**GOVERNMENT  
ARCHITECT NSW**

**FEEDBACK AND  
RESPONSE REGISTER**

Ref	Design Area	SDRP Session & Panel Feedback	Response	Report / Design Reference
	SDRP Session 4: 31.07.2019 (Developed Schematic Design)			
		Since SDRP03, the panel recognises internal clinical planning has been the focus of the design process, resulting in significant changes to the planning of the hospital. The following issues have arisen from updated internal planning:	/ The final stages of Schematic Design has involved clinical planning, budget and design consolidation. / This process has required the review and rationalization of the building form and briefed area to ensure functionality and optimum cost efficiencies are achieved. / This has resulted in a rationalized building form that reflects the project brief and budget

Figure 117. Floor Plan - Level 4, Block & Stack

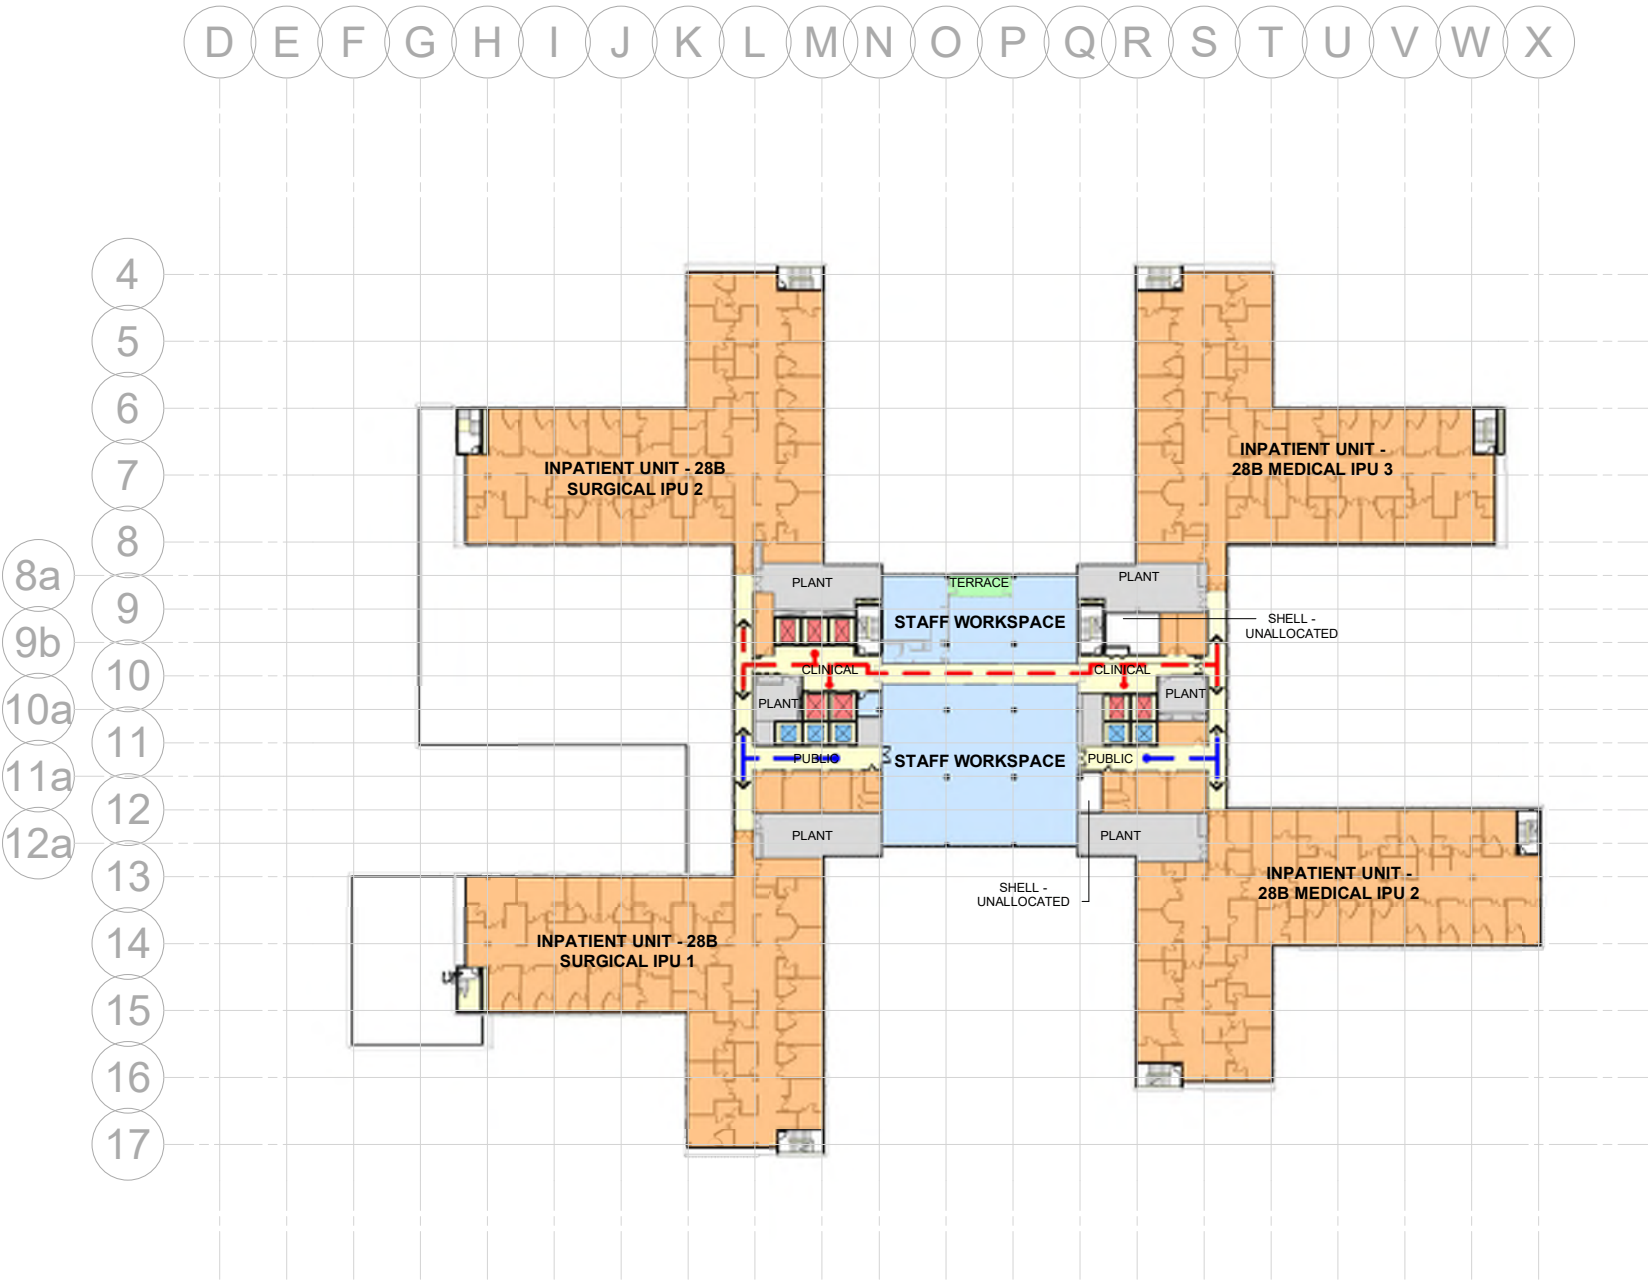
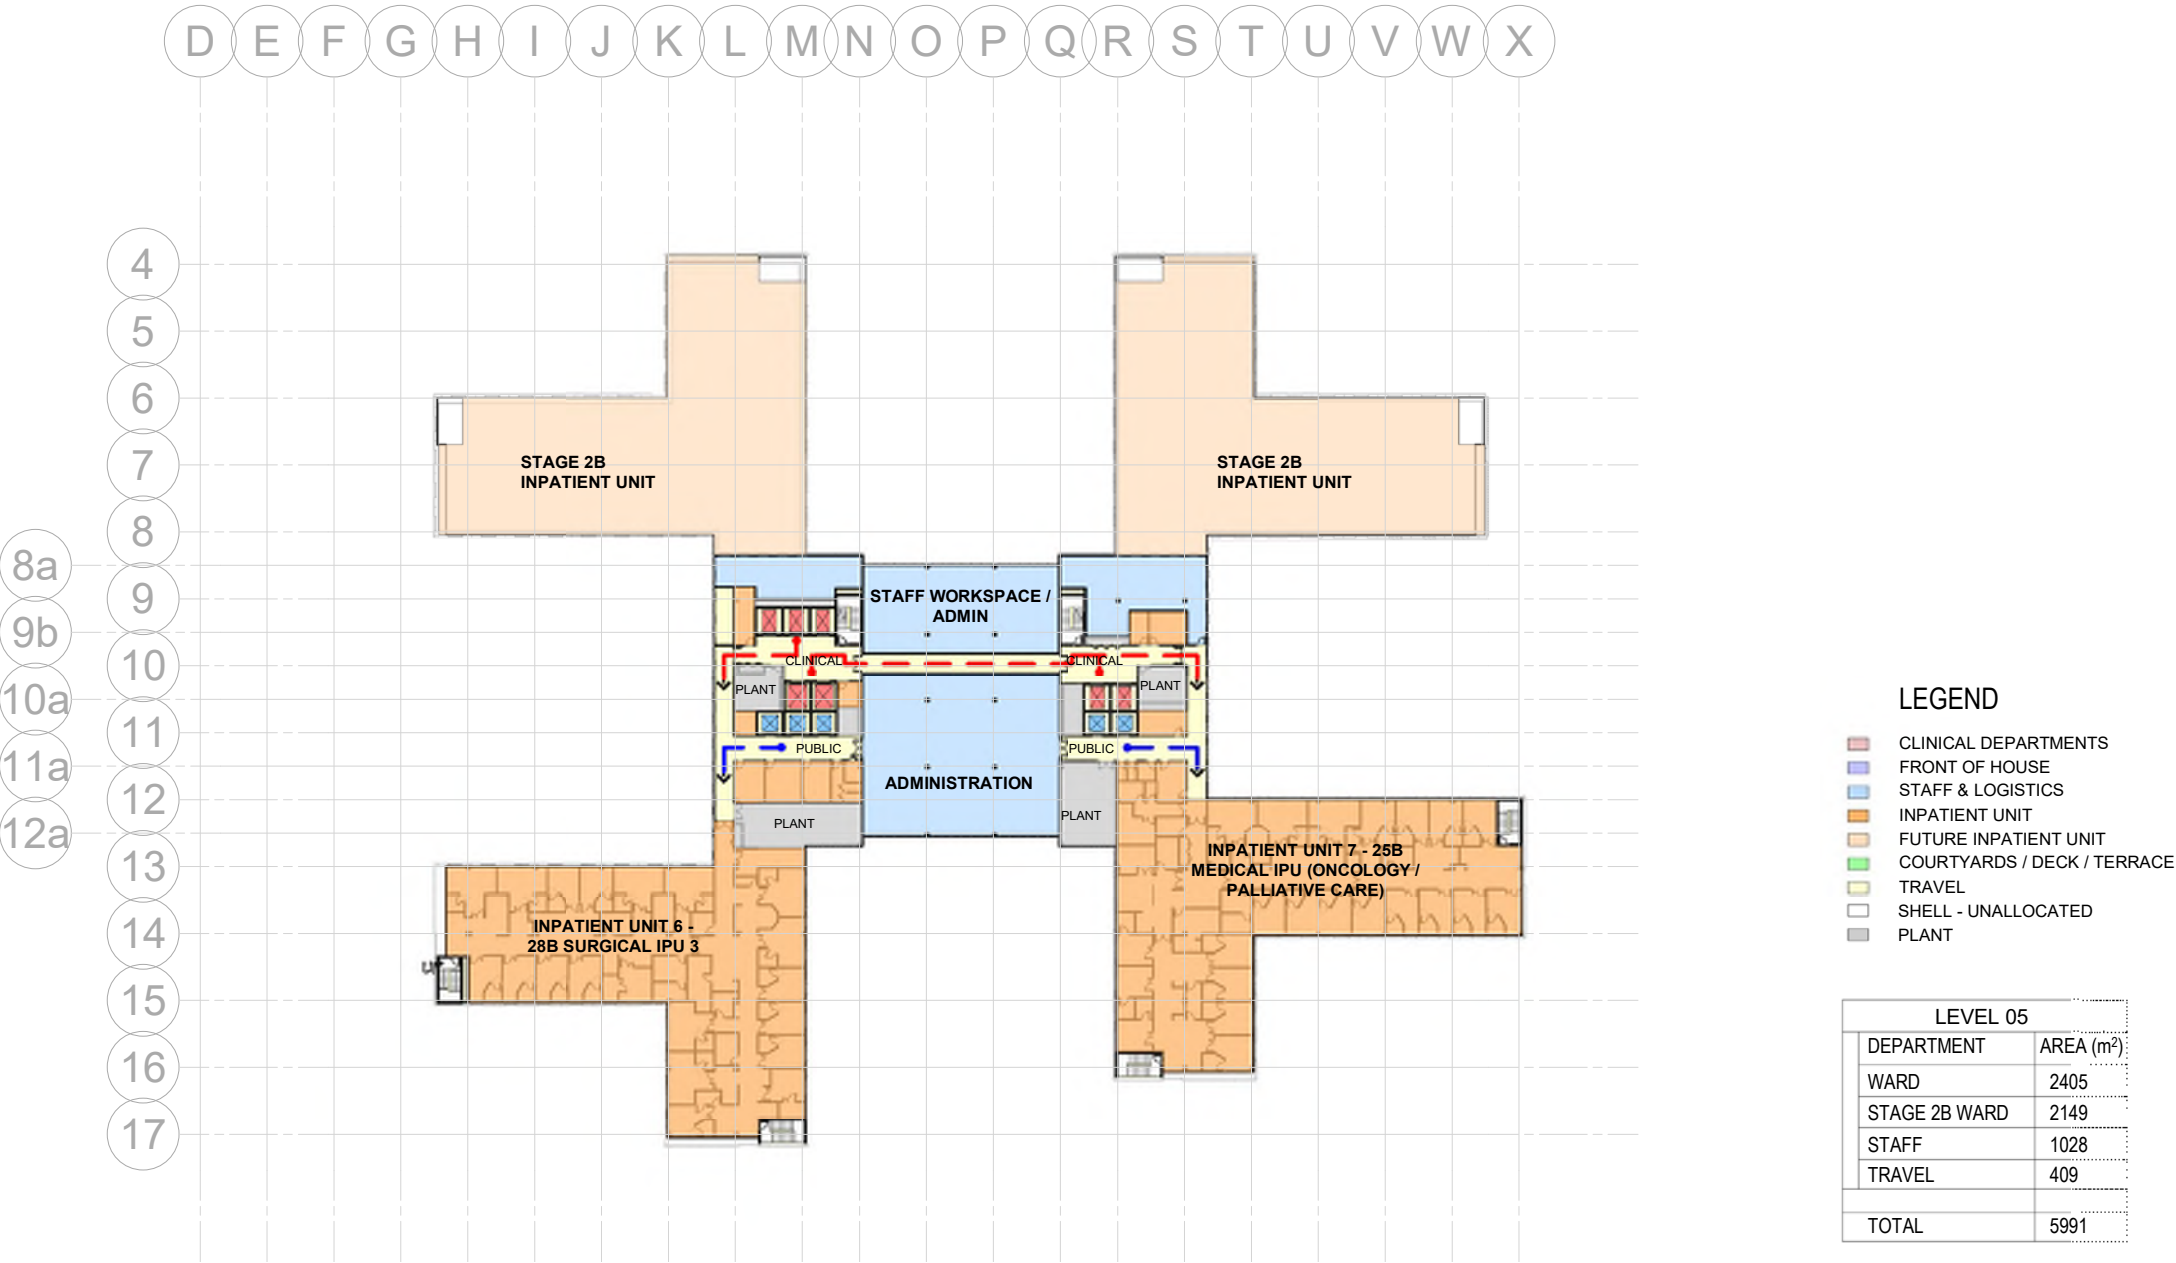
4.8	Architecture	loss of all sky gardens on level 4 and 5	/ A staff balcony has been re-introduced to the north west co-share admin zone at level 4. Balconies at level 5 have been removed from the brief due to potential down-draft impacts associated with proximity to the helipad.	Refer section 6.1 & fig.105
